Title - Sujet Fire Suppression System&Fire Alarm Fire Suppression System and Fire Alarm Replacement	
Solicitation No. - N° de l'invitation EP076-201304/A	Amendment No. - N° modif. 011
Client Reference No. - N° de référence du client 20201304	Date 2021-04-07
GETS Reference No. - N° de référence de SEAG PW-\$\$\$FG-374-79676	
File No. - N° de dossier fg374.EP076-201304	CCC No./N° CCC - FMS No./N° VME
Solicitation Closes - L'invitation prend fin at - à 02:00 PM Eastern Daylight Saving Time EDT on - le 2021-04-13 Heure Avancée de l'Est HAE	
F.O.B. - F.A.B. Plant-Usine: <input type="checkbox"/> Destination: <input checked="" type="checkbox"/> Other-Autre: <input type="checkbox"/>	
Address Enquiries to: - Adresser toutes questions à: Vani-Machado, Alba	Buyer Id - Id de l'acheteur fg374
Telephone No. - N° de téléphone (873) 355-4048 ()	FAX No. - N° de FAX () -
Destination - of Goods, Services, and Construction: Destination - des biens, services et construction:

Addendum 11

T58 Building Fire Suppression System Questions
Solicitation – EP076-201304

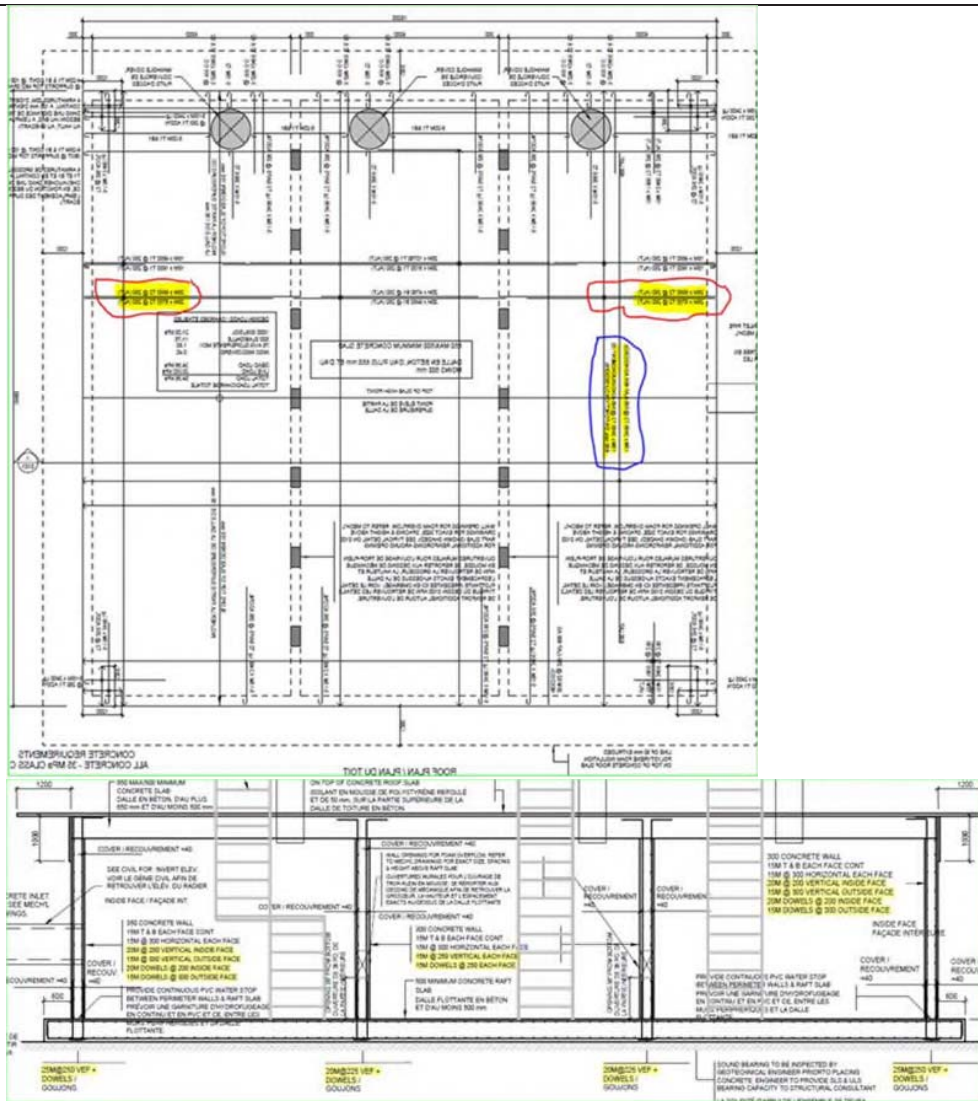
Q 30 - In drawing S102, section A-A/S101 – CROSS-SECTION, the wall reinforcement is shown on the side of each wall. Also bottom of each wall is shown vertical reinforcement which is different from the vertical reinforcement shown on the side of the walls. See section “A-A” below. Can you please clarify which vertical reinforcement should be used?	A 30 – We have revised our wall reinforcement in section A-A/S102, refer to clouded areas on S102 in addendum for further details.

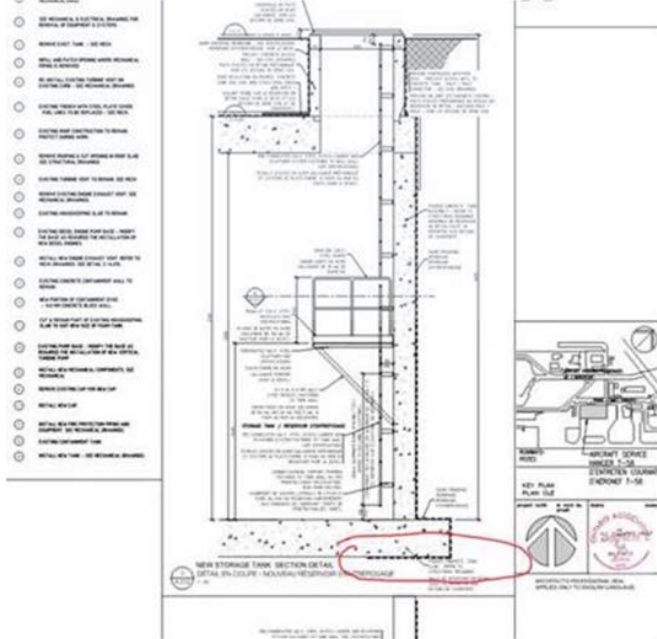
Q 31 - Phase plan T.000 indicates the requirement to install 300mm fire protection main pipe in phase 1A. However, work under phases 3A,B,C,D indicates rough-in for 300mm pipe. Please clarify in which phase the 300mm pipe will be completed?

Q 31 – as indicated in the phase 1A note, the 300 mm diameter pipe must be installed in its entirety across the hangar during Phase 1A to bring water to zone valves located in the new addition.

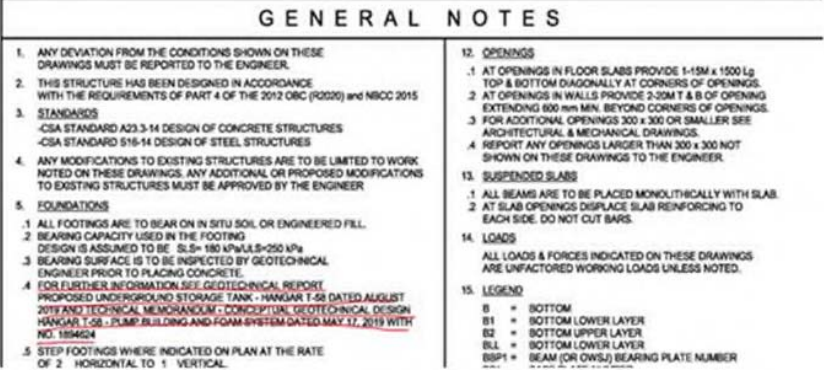
Q 34 - Considering that the construction of new valve room (phase 1A) and construction of new storage tank and exterior civil (phase 2) work will have some work overlap, can you please confirm if these phases (1A & 2) can be done at the same time?

A 34 – Phasing overlap is understood and acceptable. All construction activities and modifications to the phasing plan are subject to review and approval by Departmental Representative.

E.304

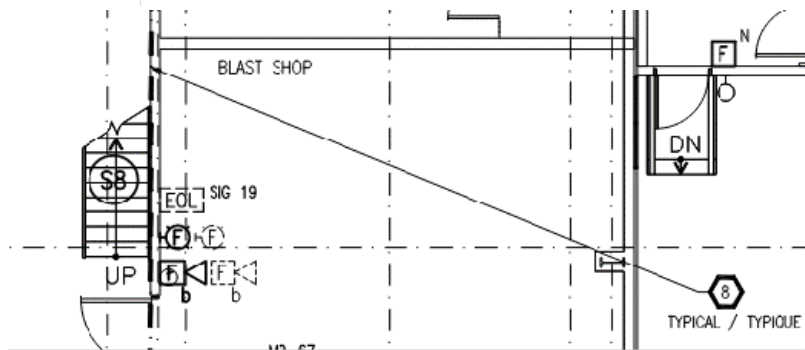
3 TYPICAL
REPLACE EXISTING FLAME DETECTOR AND ADDRESSABLE MODULE. EXISTING MOUNTING HEIGHT APPROXIMATELY 5 METERS A.F.F.

E.309

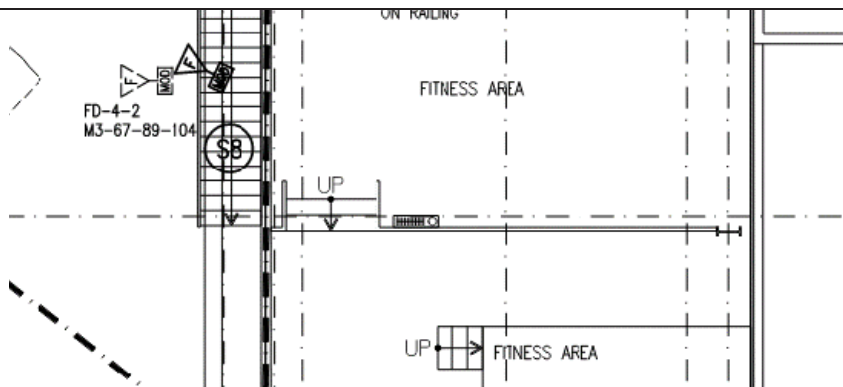
8 TYPICAL
FLAME SENSORS TO BE MOUNTED 1200mm A.F.F.

This typical note isn't pointing to a device.

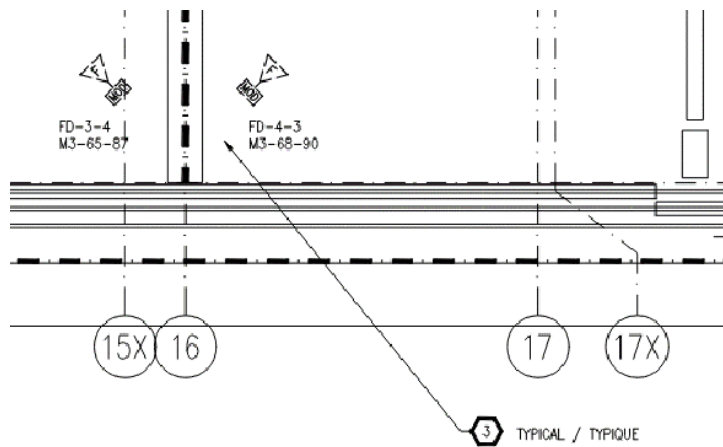
(is this the same as shown on E304, note 8?)

Q 55 - In regards to the flame detectors, can you confirm that all of the existing flame detectors shown are to be replaced with new? Typically existing fire alarm devices are shown on the drawings to be removed with new devices shown next to these, but for the flame detectors, only the existing ones are shown with a typical note to provide a new one.

A 55 – All flame detectors are to be replaced.
